# ISC-C1 Rack

Title <b>ISC System Wiring Diagram</b>		
Size B	Number <b>D1900511</b>	Revision <b>V8</b>
Date: 8/29/2022	Sheet of 1	38
File: C:\Users\...ISC_C1_SH1.SchDoc	Drawn By: Filiberto Clara

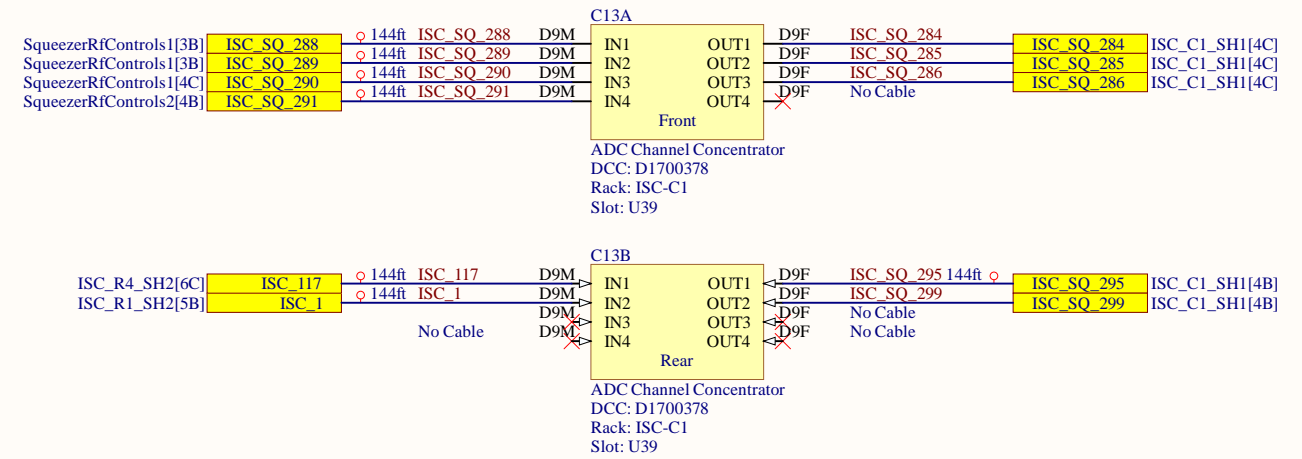
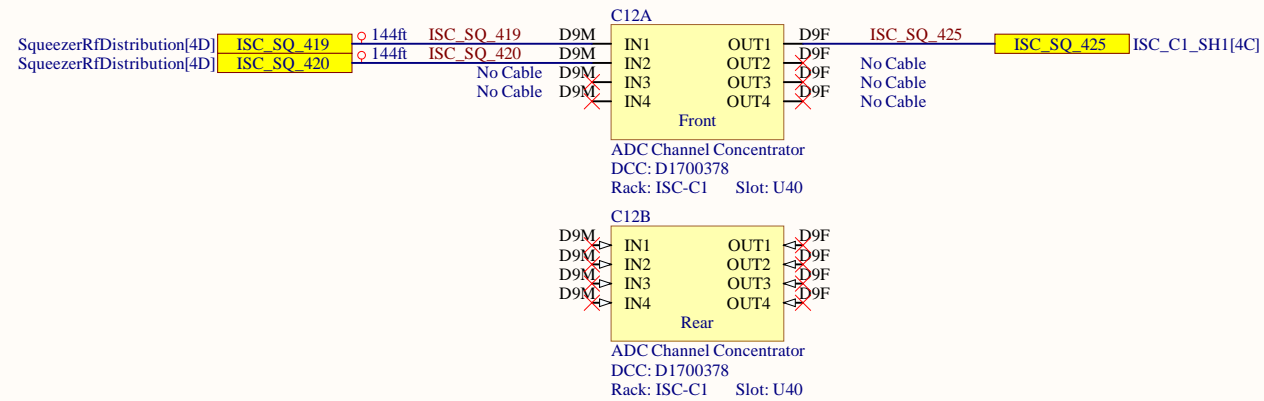
Reverify cables, showing ISC\_426 and ISC\_427 as connected in ISC-R5 rack but not in CER.

Needs Label

Following cables are not connected in the CER:  
ISC\_101, ISC\_175, ISC\_242, ISC\_410, ISC\_426,  
and ISC\_427

# ISC-C3 Rack

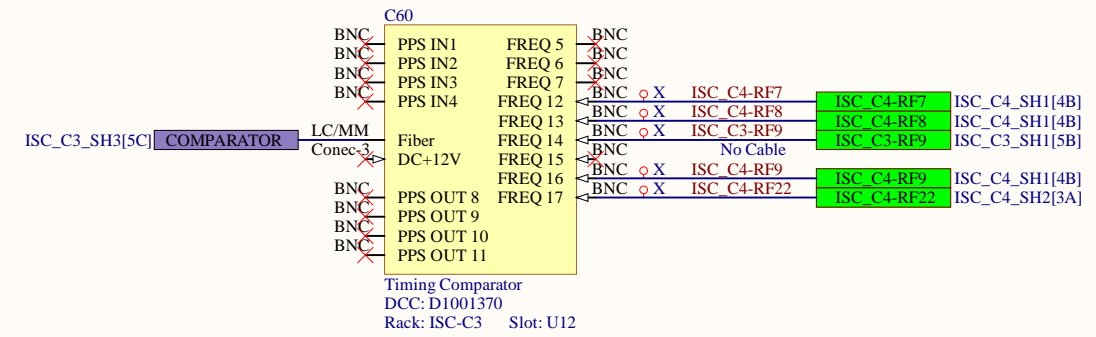
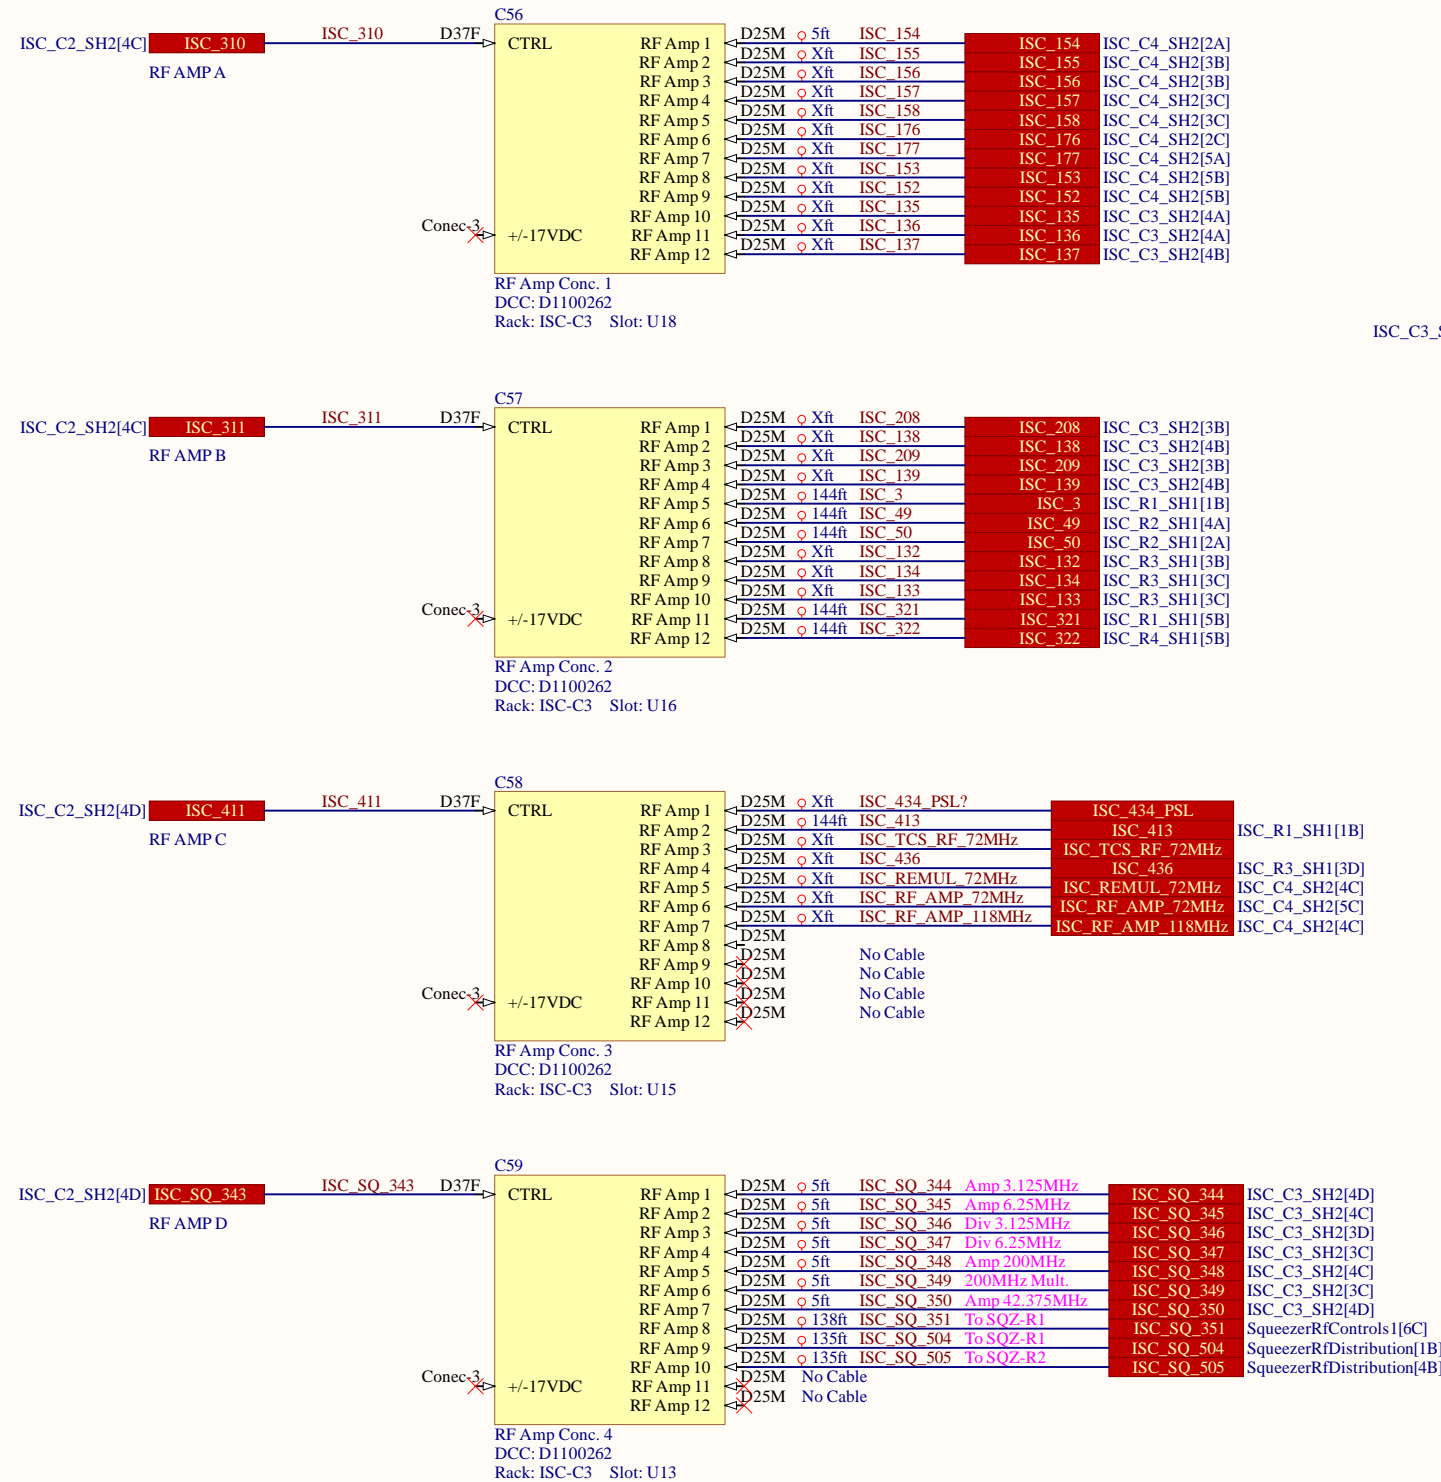
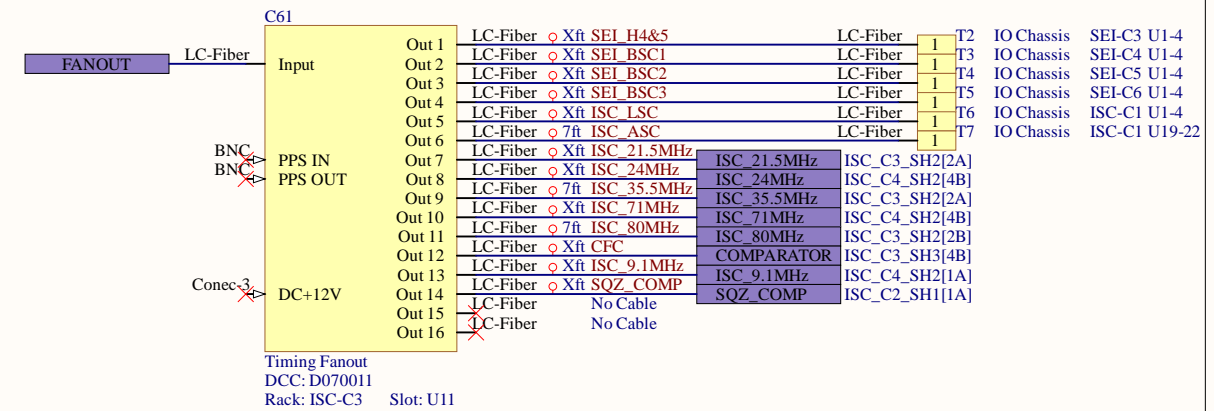
Need Locations of other ends.  
SEI IO Chassis

# ISC-R1 Rack

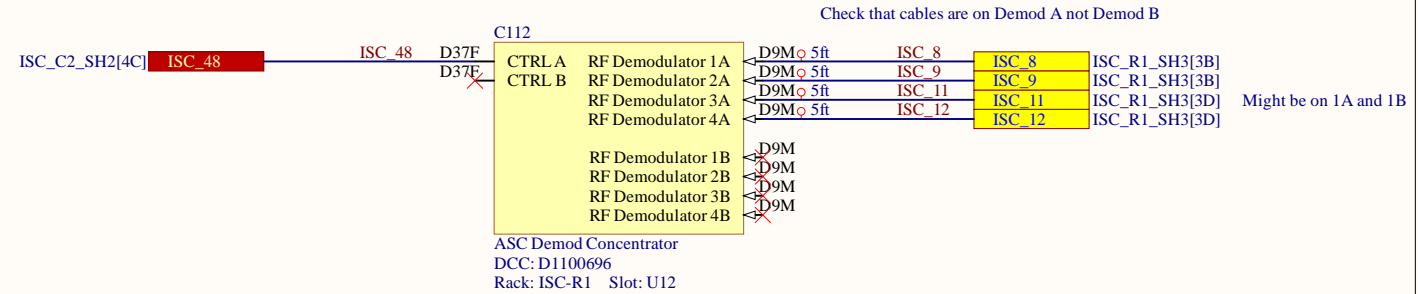
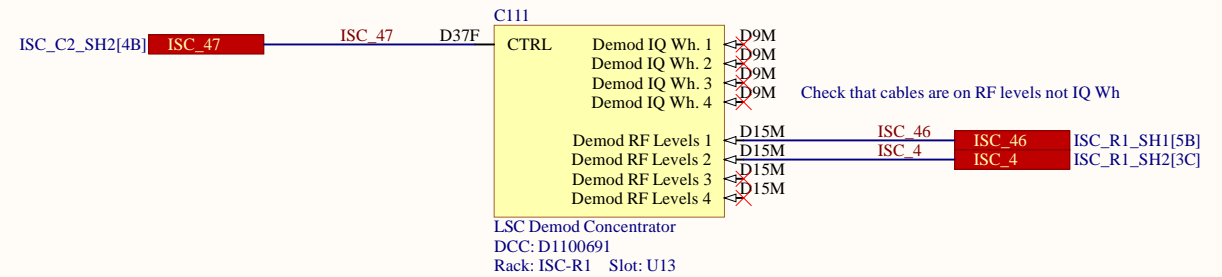
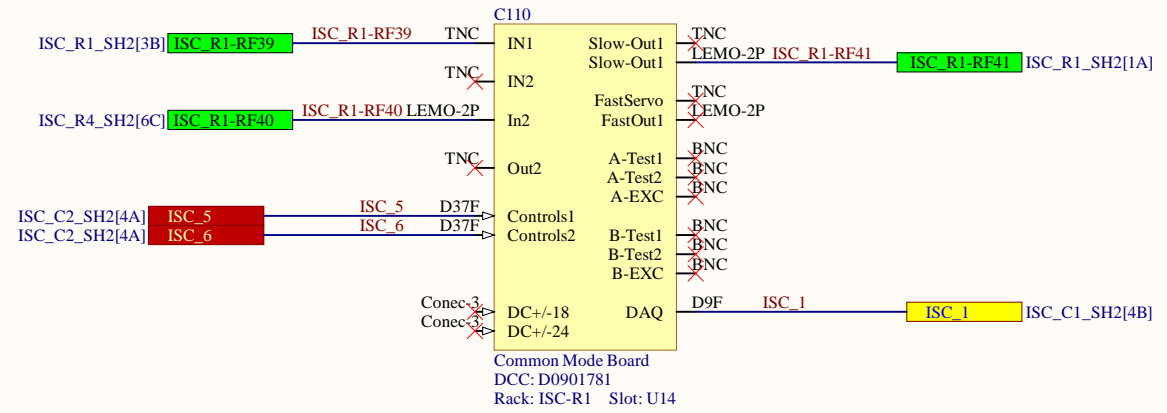
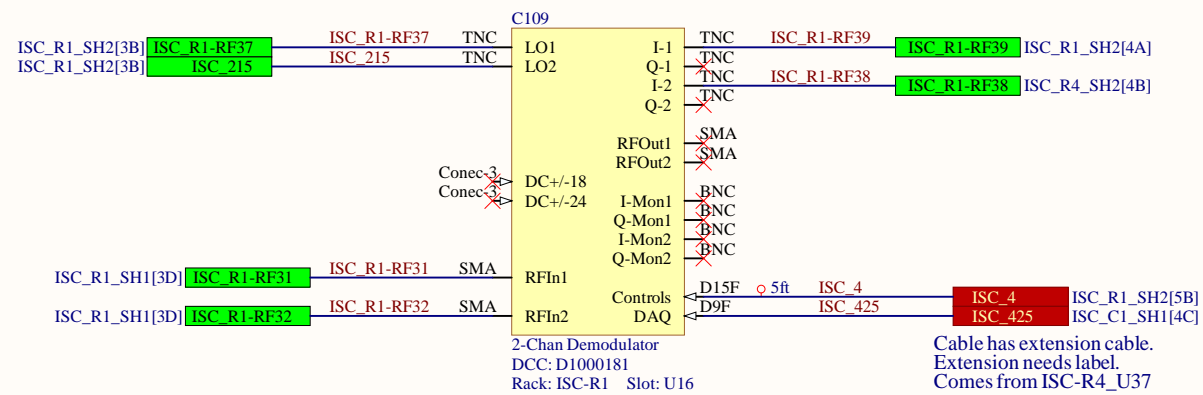
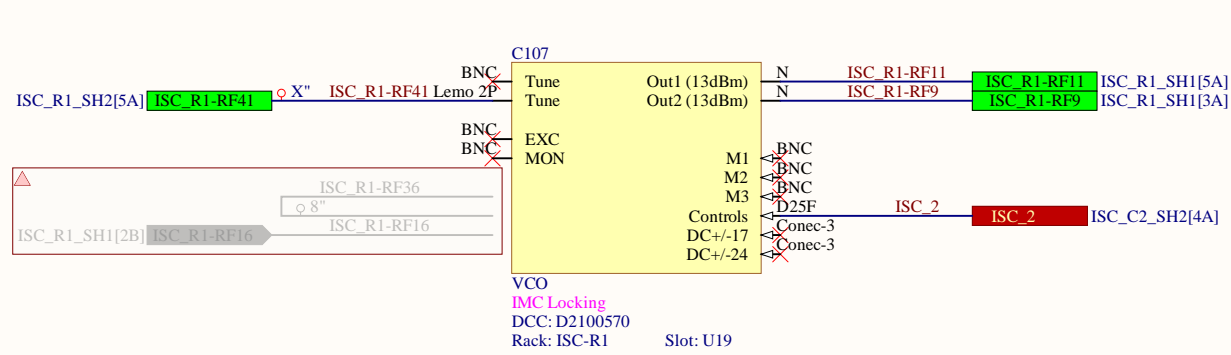
Need to Locate other end

# ISC-R1 Rack

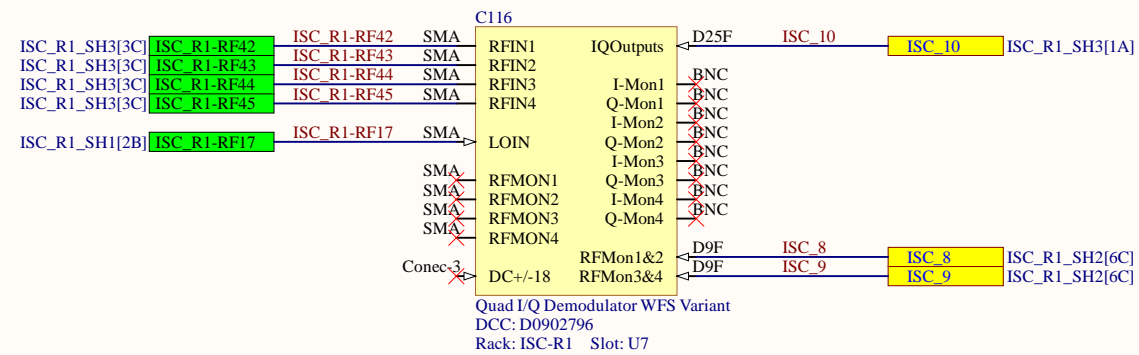
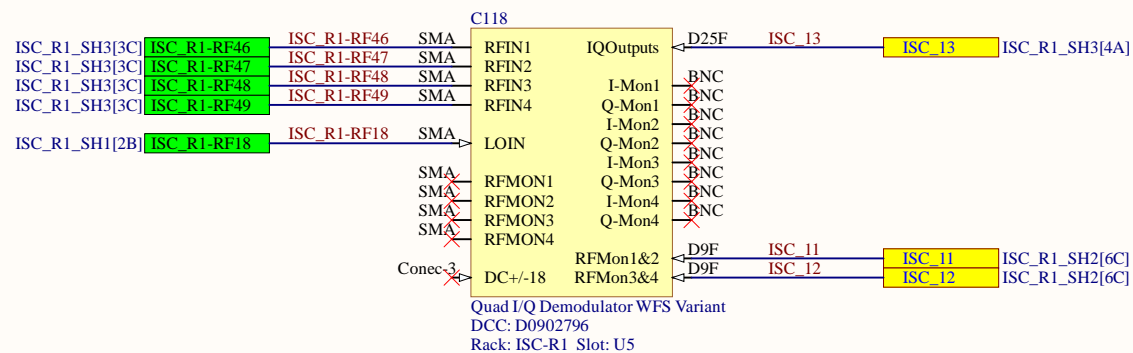
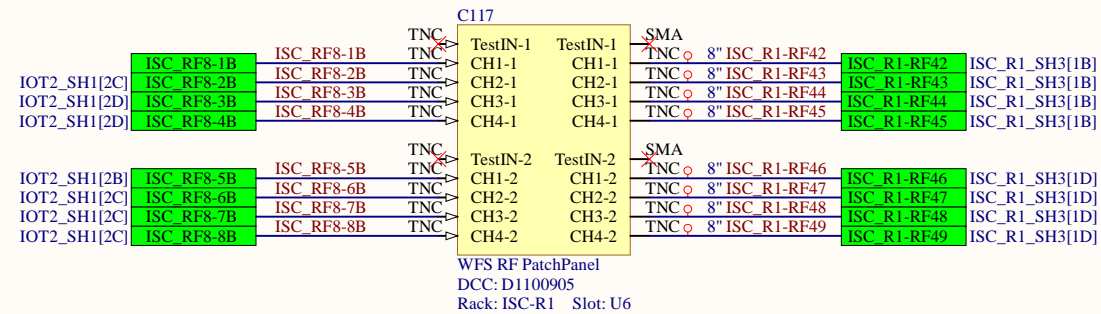
Need to locate other end

434/435 already used  
 ASC-POP\_X\_PIT/YAW

# ISC-R4 Rack

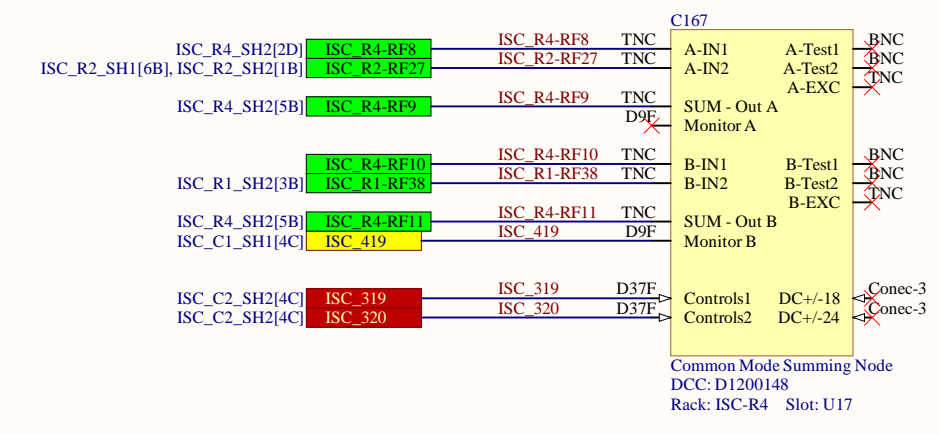
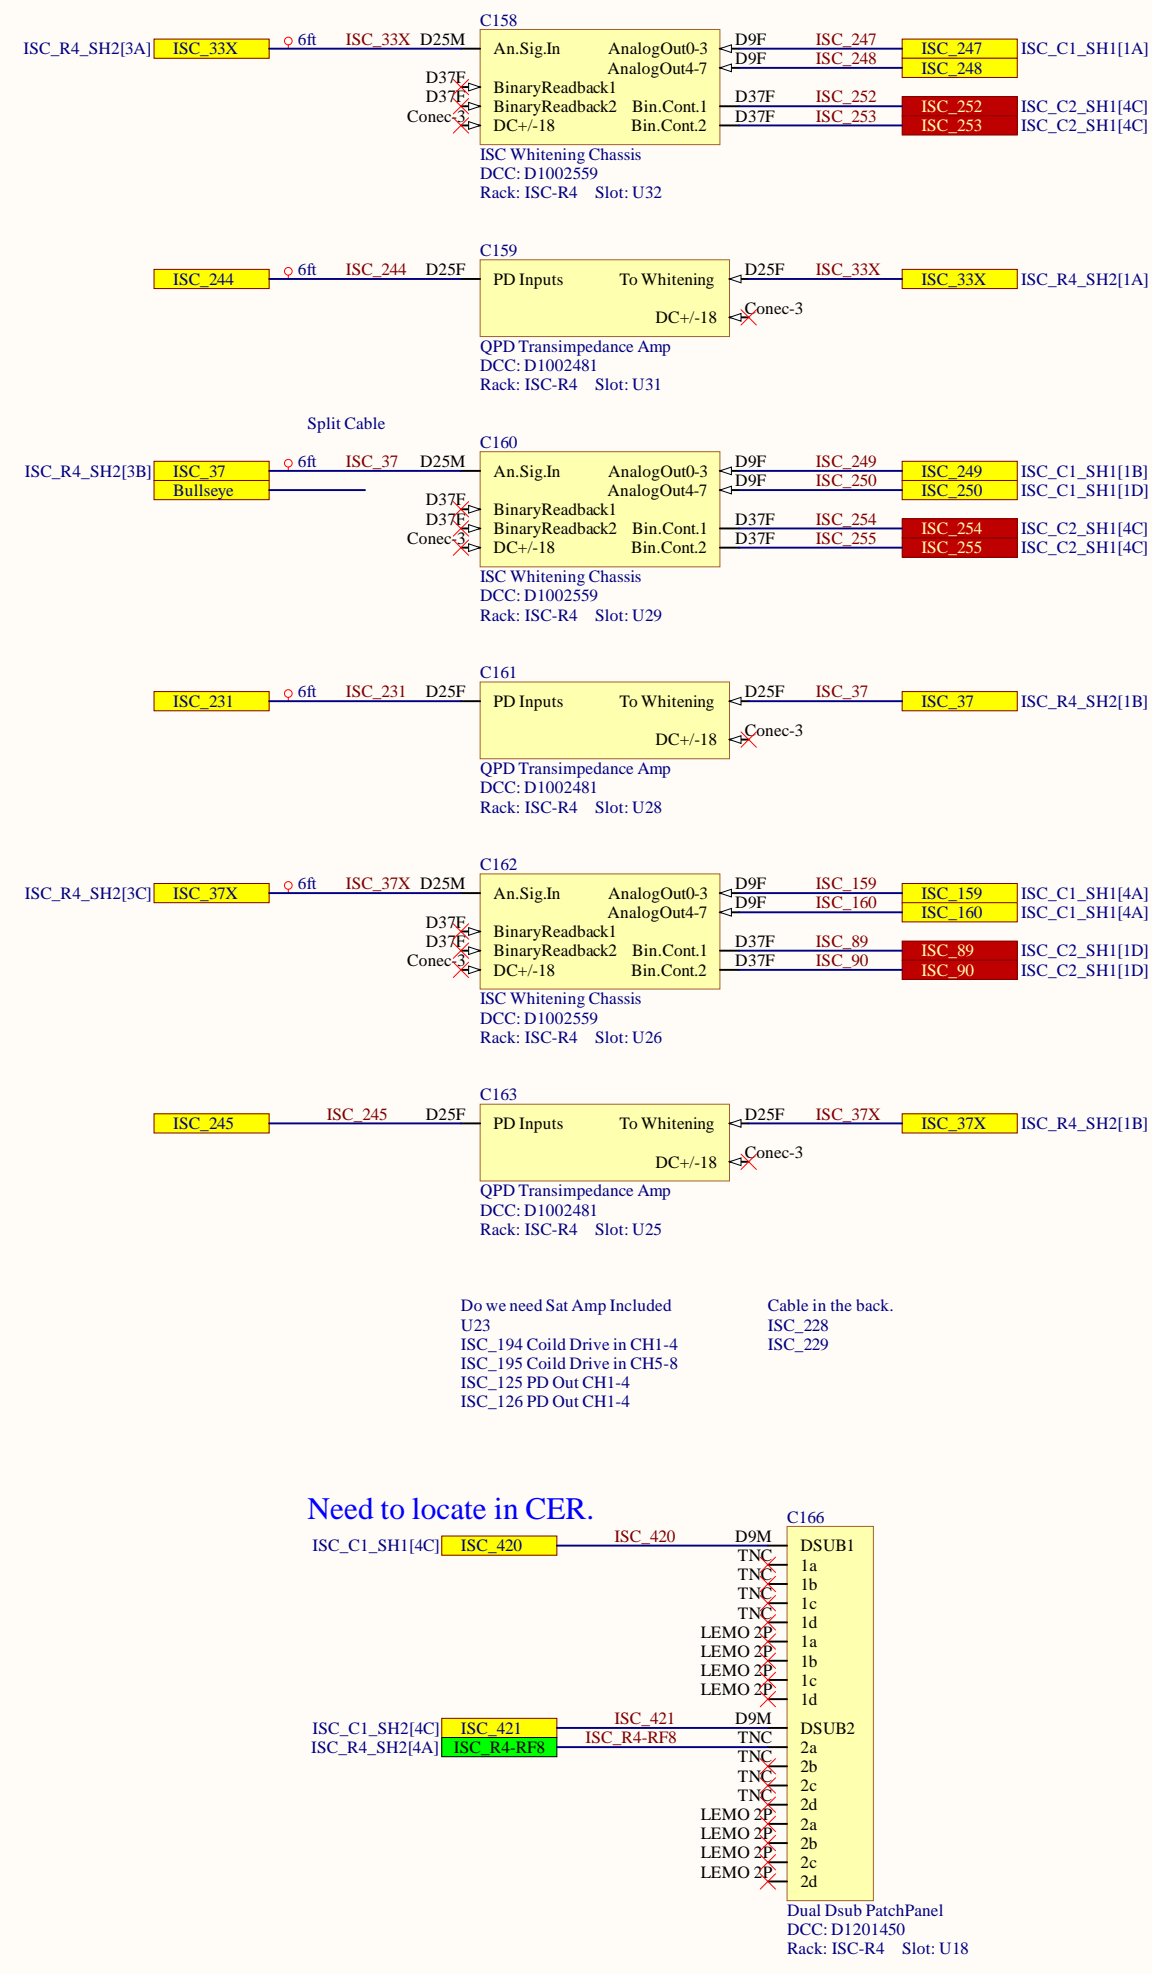
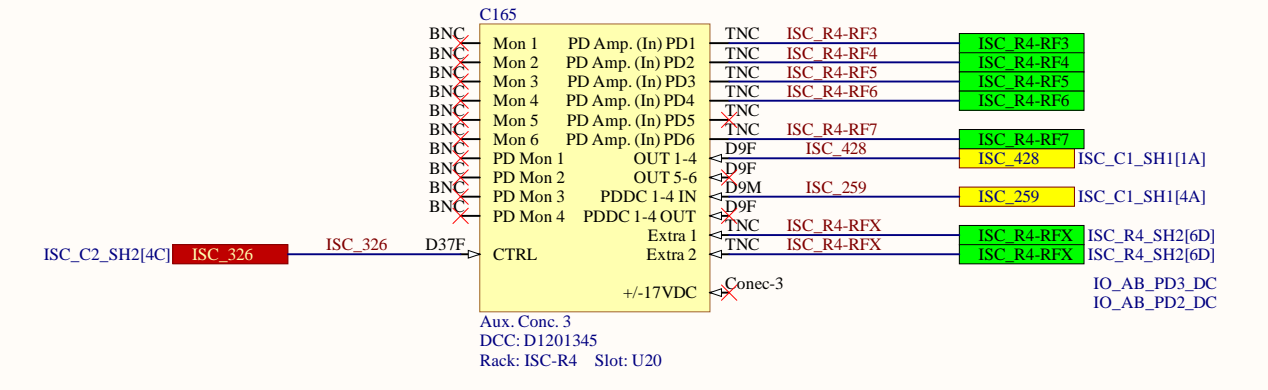
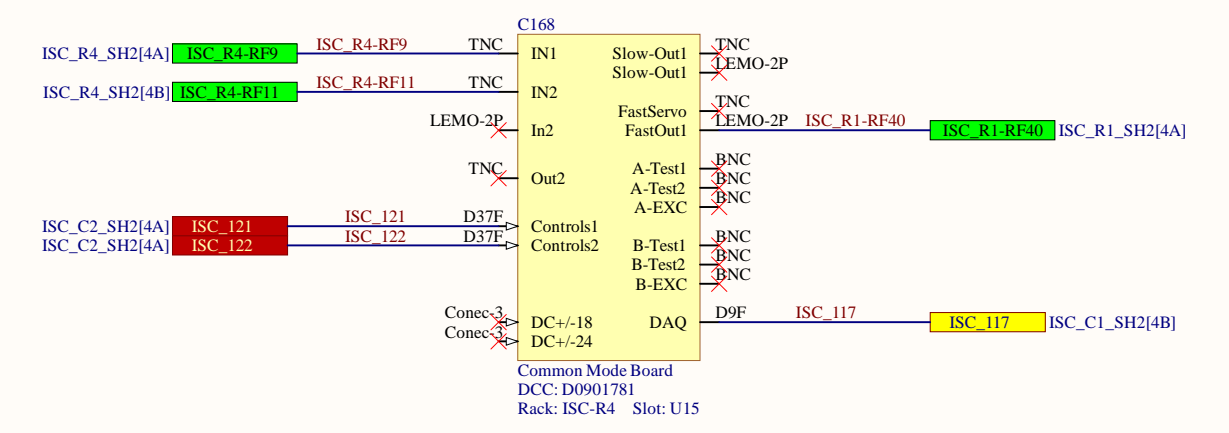
Otherside not labeled. RED  
Otherside not labeled. Green  
Otherside not labeled. R4 ISC1  
Otherside not labeled. R4 ISC2  
Otherside not labeled. Old label H1\_ALS\_PSL\_PD1
